Technical Note for

Alexander Schleicher
GmbH & Co.
Segelflugzeugbau
D-36163 Poppenhausen

ASW 22, ASW 22 B ASW 22 BE ASH 25

Securing of L'HOTELLIER quick-release connectors (ball and swivel joints) as per Airworthiness Directive (AD) "93-001 L'HOTELLIER" of the German Civil Aviation Authority (LBA) dated March 3, 1993.

Example of clip spring installation for ASW 22 / ASH 25 at the L'Hotellier-quick connection of the flap control rod IX, AS-No. 220.45.0047 wing / wing intersection at span 3.8 m of right wing. Left wing: install like reflected image!

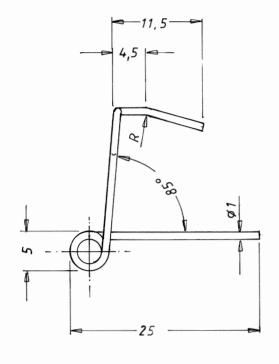
The L'HOTELLIER quick-release connector of the flap push rod at the wing-wing-separation point at 3.8 meters CANNOT be fitted with the "Wedekind-safety sleeve"! At this location is must be secured by means of safety pins (spring clips) only, as recommended by SCHLEICHER or other glider manufacturers. This item (AS P/N 99.000.2043) can be obtained from SCHLEICHER.

In addition one pair of spring clips, AS P/N 99.000.2043, for the L'HOTELLIER quick-release connector of the flap push rod at the wing-wing-separation point at 3.8 meters.
